re: **Response to City Comments**
 Proposed Residential Development
 475 Terry Fox Drive – Ottawa, Ontario

date: July 14, 2026

file: PG7418-MEMO.01 Revision 4

Project Ironclad Developments Inc. Slope Stability Analysis 475 Terry Fox Drive, Ottawa, Ontario		
	Figure No. Figure 1A - Section A - Proposed Conditions - Static Loading		
	Drawn by: NFRV	Company: Paterson Group	
	Date: 2026-01-05	File No. PG7418

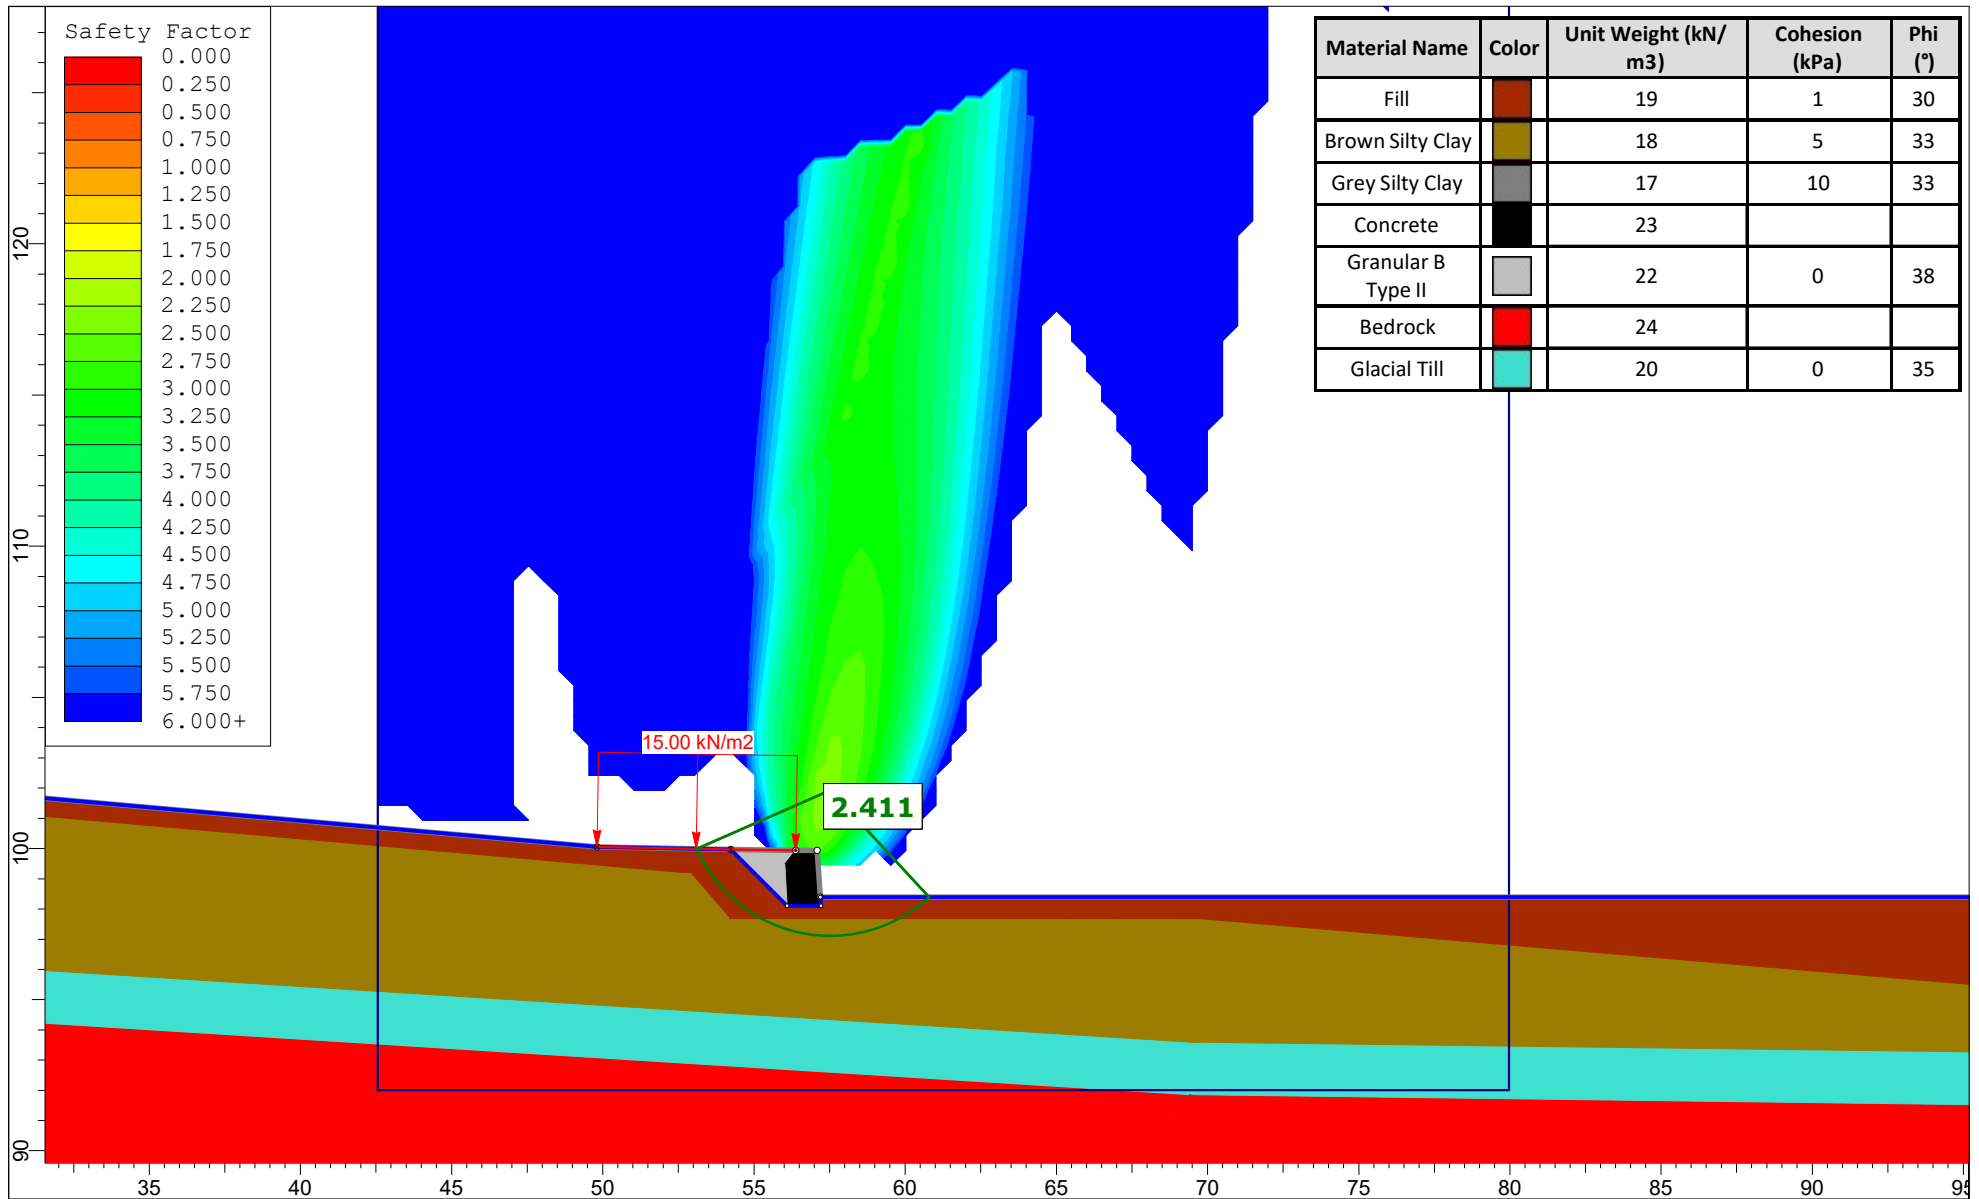
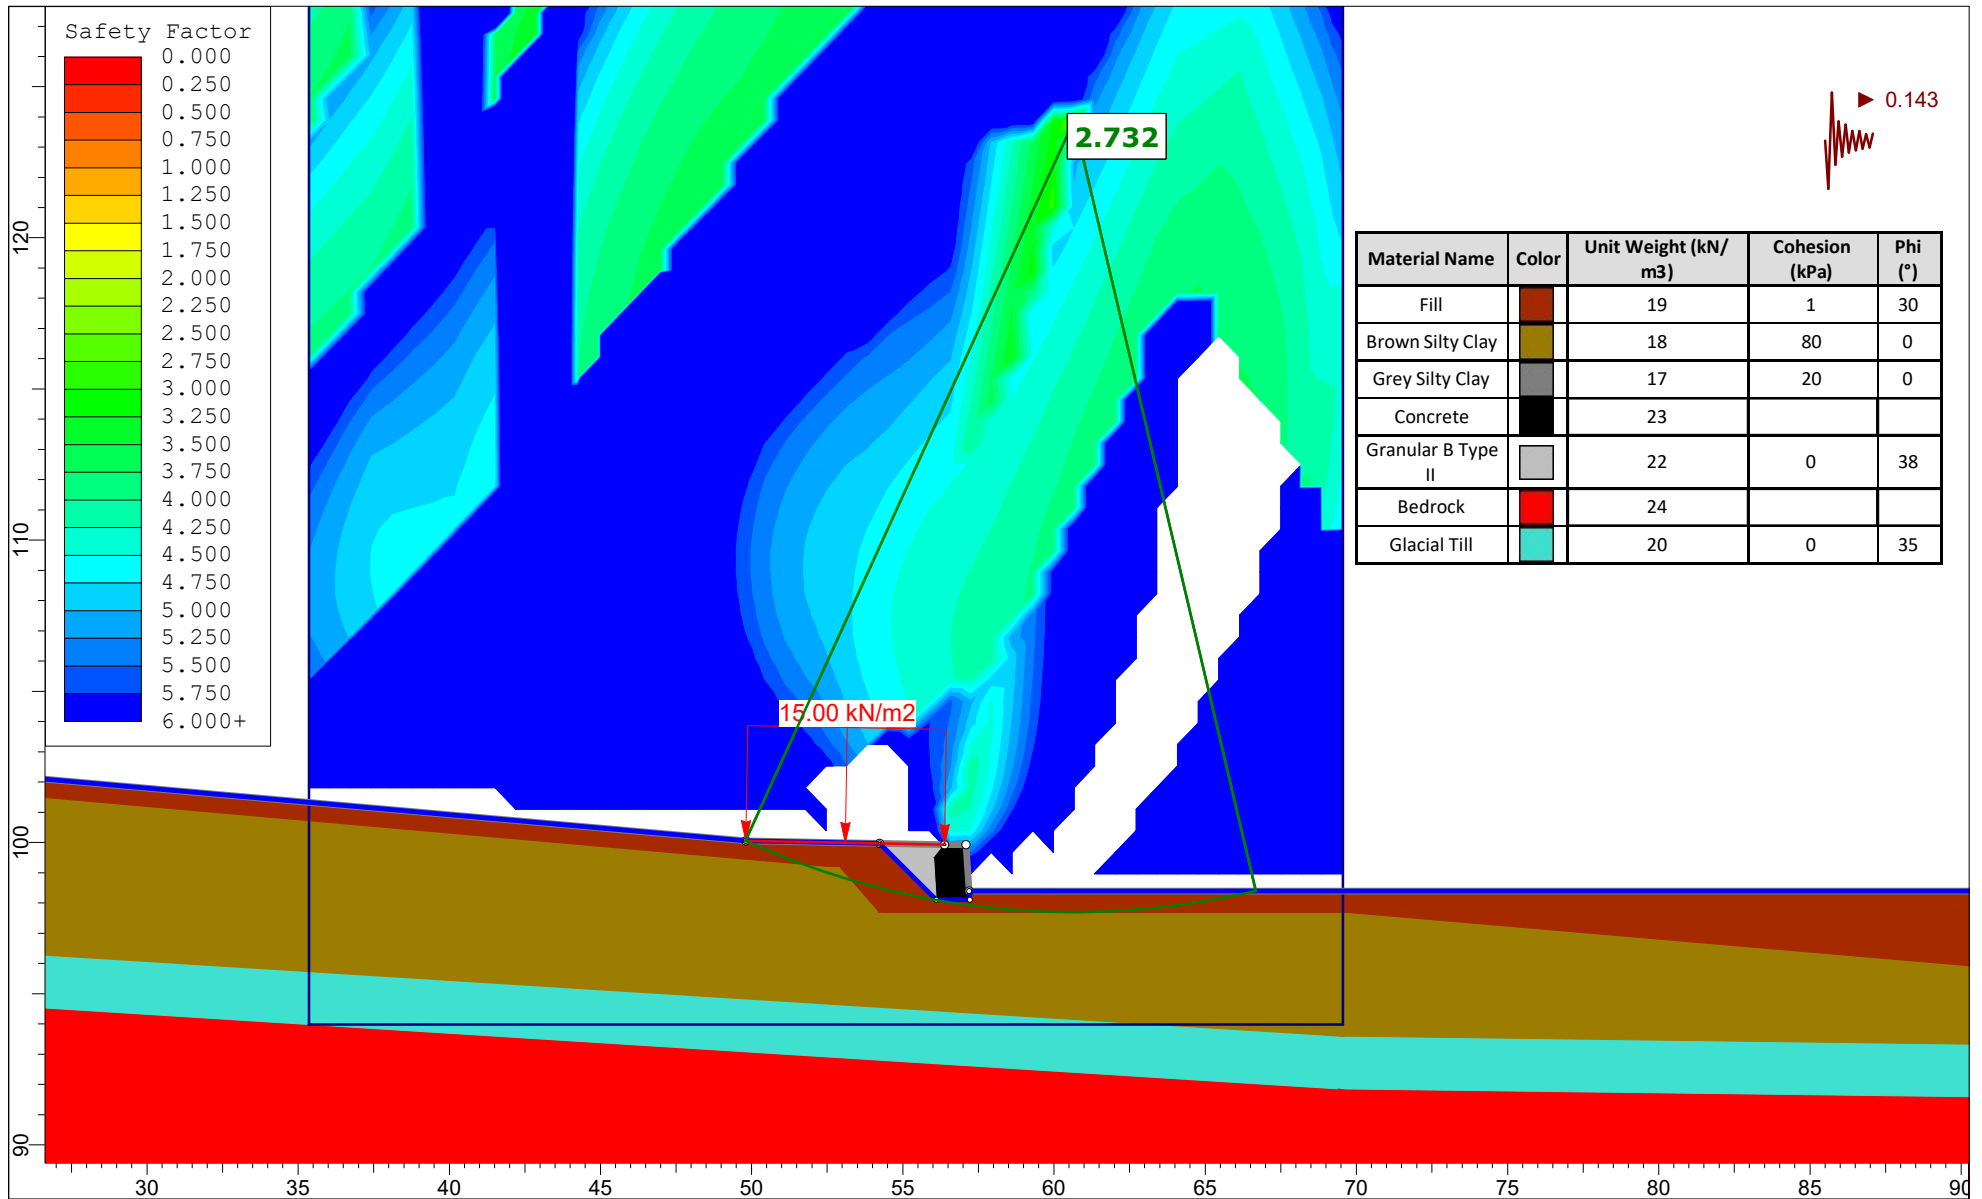
Comment 6: *Please coordinate with the civil consultant to confirm if the proposed retaining walls on site will require a global stability analysis report and drawings. These documents will be required to make for a complete submission if the proposed retaining walls are greater than 1.0 m in height.*

Comment 73: *Thank you for providing a global stability analysis for the highest section of the retaining wall. Although this is the highest section of the retaining wall, can you confirm that it is also the most critical cross-section that could be analyzed for this site? Perhaps the highest section of the retaining wall may not be the most critical if elsewhere along the wall larger trees are being proposed closer to the top of wall? Please confirm.*

Response: Based on Paterson's review of the currently proposed grading concepts, retaining walls reaching up to 1.54 m in height will be required. Based on this information, Paterson has subsequently prepared a global stability analysis of the highest and most critical segment of the proposed retaining wall structure based on the current civil design drawings. This analysis considers a surcharge of 15 kPa, equivalent to typical traffic loading, representing trees to consider their presence along the top of the wall area.

Based on our review, the factors of safety for the static and seismic loading cases exceed the required minimum factors of safety of 1.5 and 1.1, respectively, and are considered acceptable from a geotechnical and global stability perspective. The analysis was undertaken using SLIDE, a computer program which permits a two-dimensional slope stability analysis using several methods including the Bishop's method, which is a widely used and accepted analysis method. The cross-sections are appended to this memorandum.

Response: Reference should be made to our response to Comment #7. In summary, Paterson has confirmed that the section considered is the most critical section and an additional surcharge has been applied to consider the presence of trees equivalent to typical traffic loading.

FIGURE 4

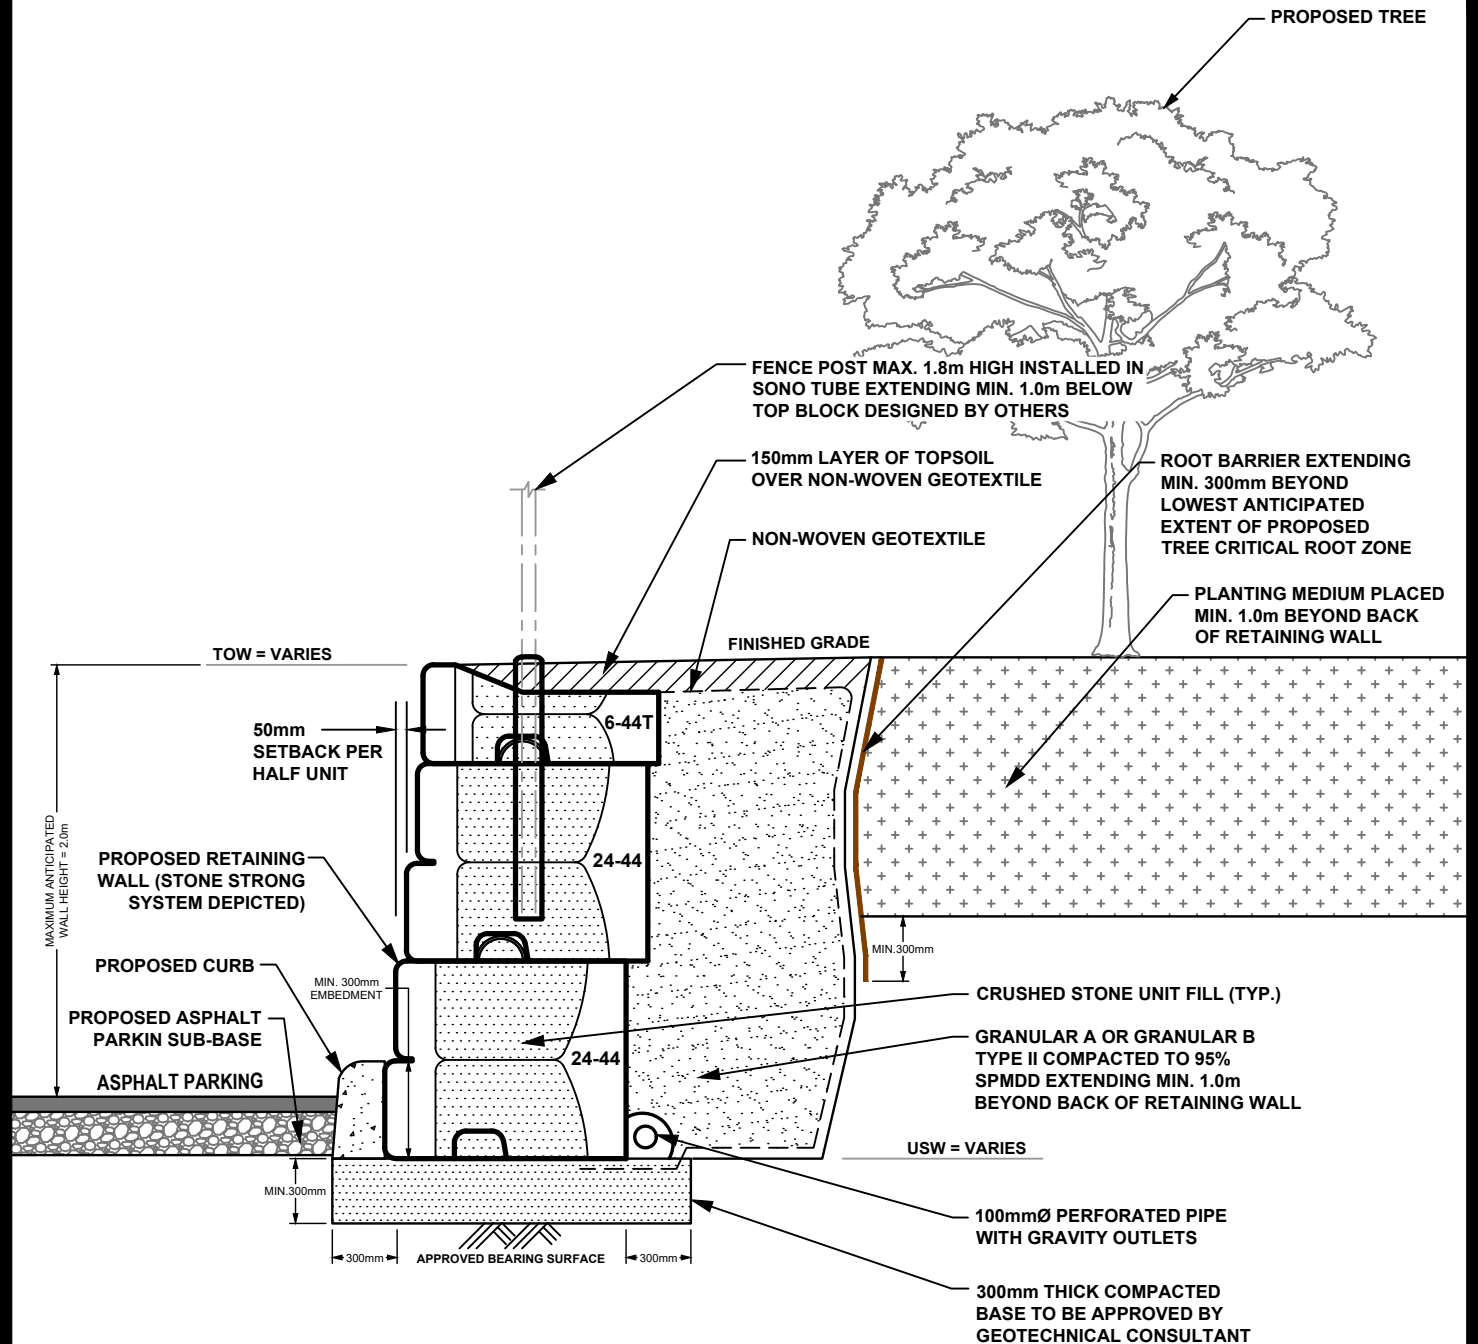
Comment 7: *Cross-sections are required for the proposed retaining walls.*

Comment 74: *[City's response to previous deficiency #7]: Noted, this comment has been moved under the comments section. Please provide the actual cross-sections of the proposed retaining wall once available.*

Response: Cross-sections of a typical segmental block retaining wall design that will be required for the proposed retaining wall during the detailed design stage has been appended to this memorandum in response to this comment. The attached typical detail provides an example of the type of retaining wall structure that is considered feasible and suitable for the subject site from a geotechnical perspective.

Response: This comment has been acknowledged; this will be provided at the detailed design stage when the retaining wall design is typically and most appropriately complete.
